**Appeal No. 19550, “Appeal of ANC 6C”**

1125 7TH ST NE (Square 886, Lot 35)

**Intervenor’s Post-Hearing Statement in Support of Appeal No. 19550**

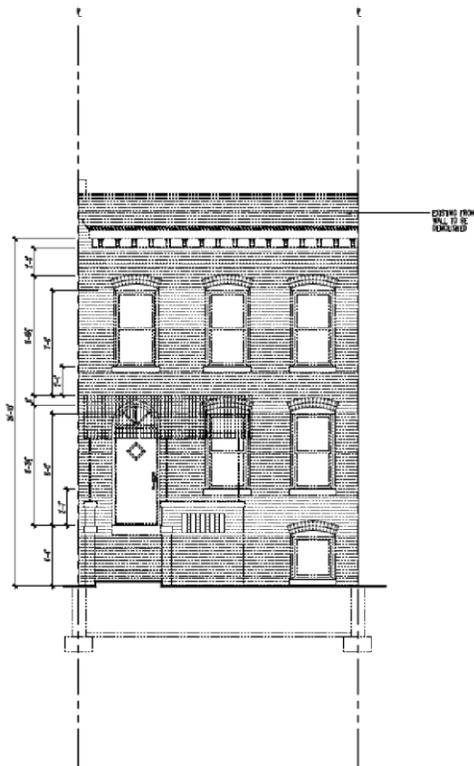
Atlas also falsely states that the cornice is located below the roof top, when in reality the cornice is at the roofline but below the parapet—similar to the cornice configuration in the above illustration from the Office of Planning. Here is a photo of the cornice (left) and a detail from Sheet A4.2 Right Side Elevation (right) showing the cornice in profile:

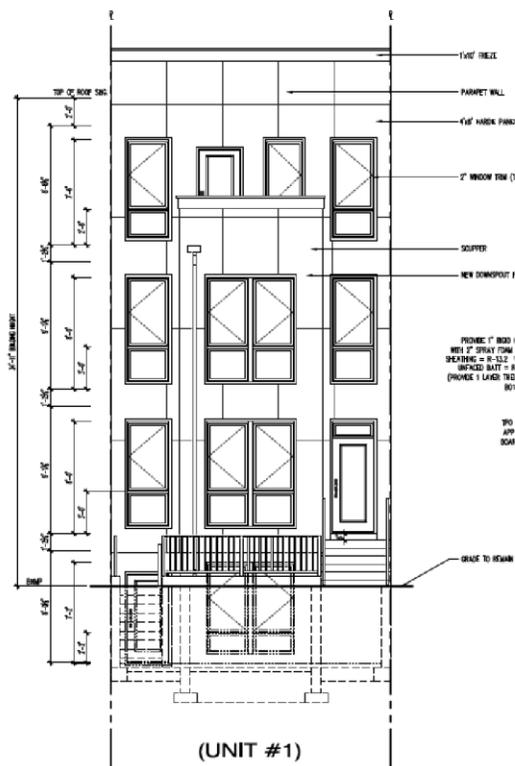
The following excerpts from the building plans clearly show the extent of the changes related to the cornice removal. Sheet A4.1 Front Elevation from B1706219 states “EXISTING FRONT WALL TO BE DEMOLISHED” and shows that the original cornice and other façade features are completely removed. The existing front porch and its roof are also removed. The proposed front elevation in Sheet A4.1 shows that in its place there is a new façade, 2-story bay window and 3rd level balcony projecting into the public space.

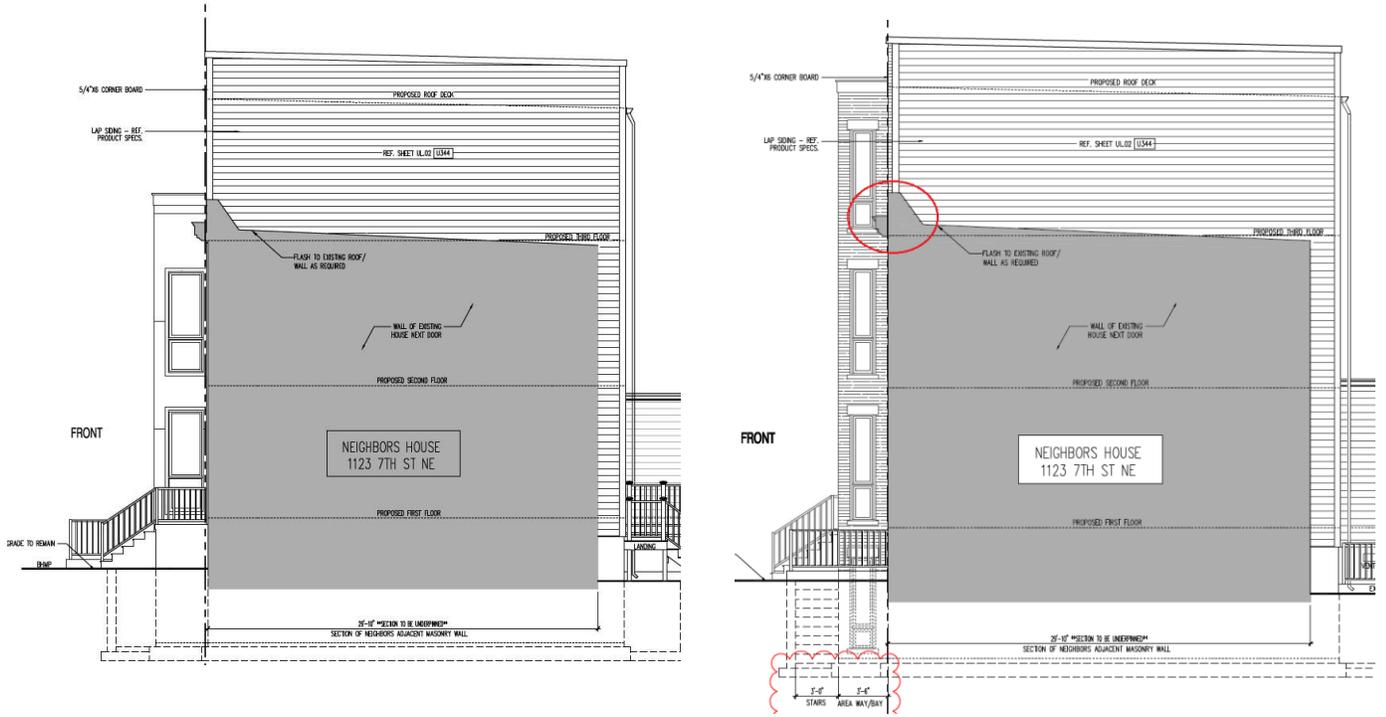
Comparing Sheet A4.2 Right Side Elevation from the original B1706219 and the revised permit B1805207 clearly shows the removal of the cornice shared with the adjoining 1123

property and the new bay window and balcony projection. See excerpts below from 1706219 (on left) and B1805207 (on right):

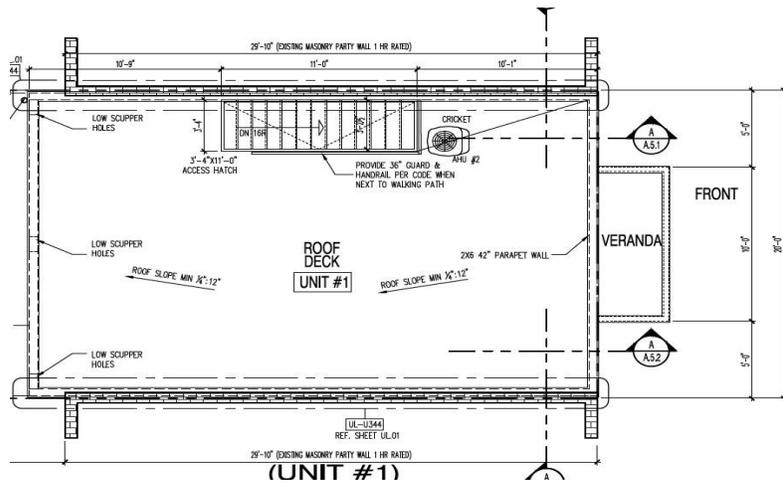
The Roof Deck Plan in Sheet A3.1 from B1706219 shows the original front wall removed and labels the 3rd story balcony projection a “veranda,” which does not exist in the revised permits:

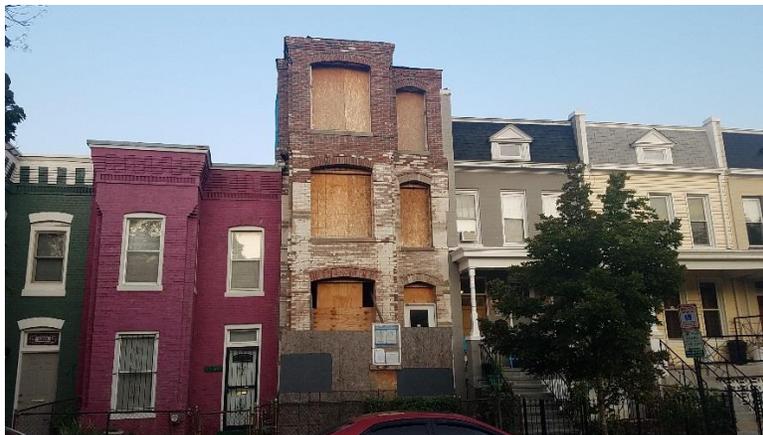
This photo taken on September 19, 2018 shows the cornice removed from 1019 4<sup>TH</sup> ST NE:

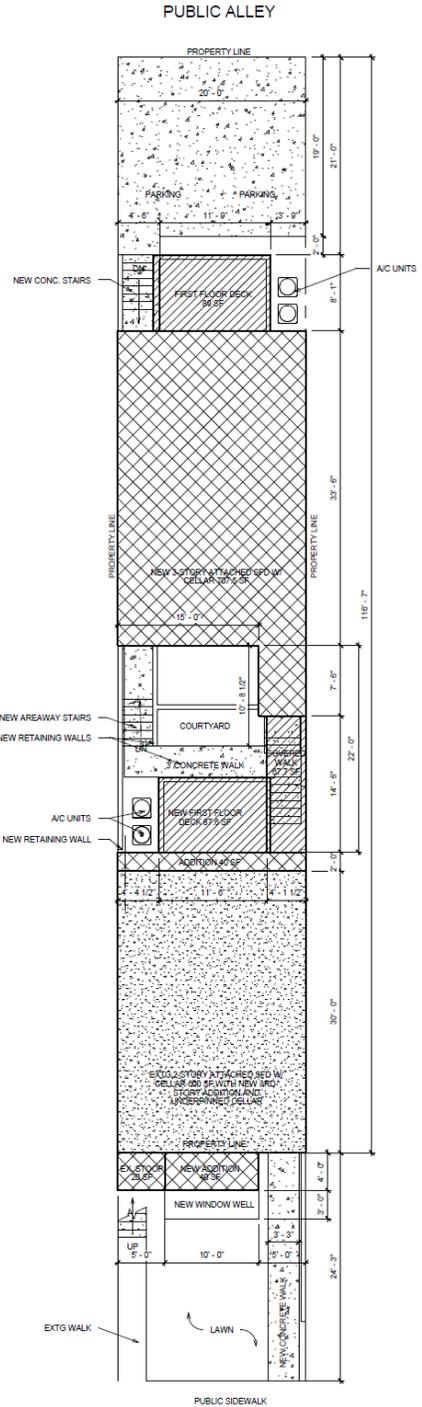
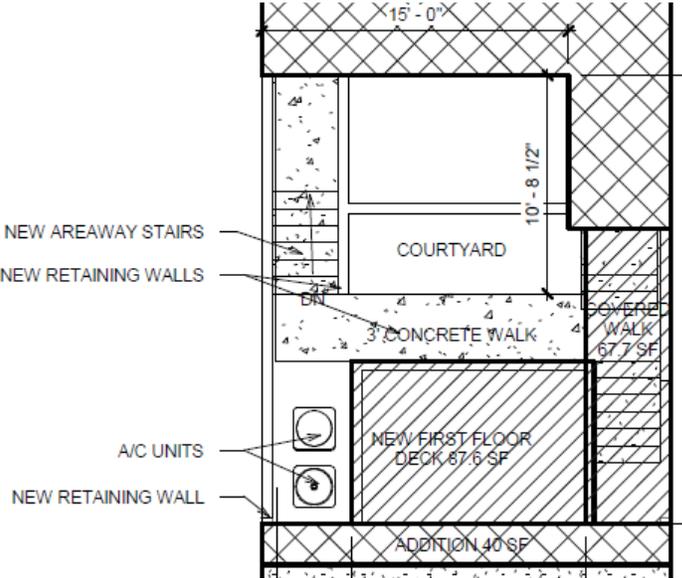
Permit application B1512853 did not meet zoning regulations. The "Project Data" summary on Cover Sheet C1.0 [**EXHIBIT A**] proposes converting the existing row house into 4 dwelling units, which is not allowed as a matter of right in the R-4 (now RF-1) zone. The Proposed Site

Plan included on Sheet C1.0 also clearly shows 4 A/C Units, two for each building, which also indicates Atlas' intention to build 4 dwelling units at 1125 7<sup>TH</sup> ST NE.

In addition, the project data table incorrectly describes the property as being located in the R-5-B zone district. This table also states that the project involves 3 stories plus a mezzanine and cellar level, which is also not allowed under the zoning regulations that existed at the time (or today), as shown in this excerpt from sheet C1.0:

Moreover, this “foundation level” permit proposed a below-grade corridor connecting two separate buildings, which is located on the opposite side of the property compared to the “breezeway/lobby” in B1706219 and subsequent permit revisions incorporated in this BZA appeal. This is clearly depicted in the Proposed Site Plan from Sheet C1.0 in application B1512853, which describes the foundation level only:
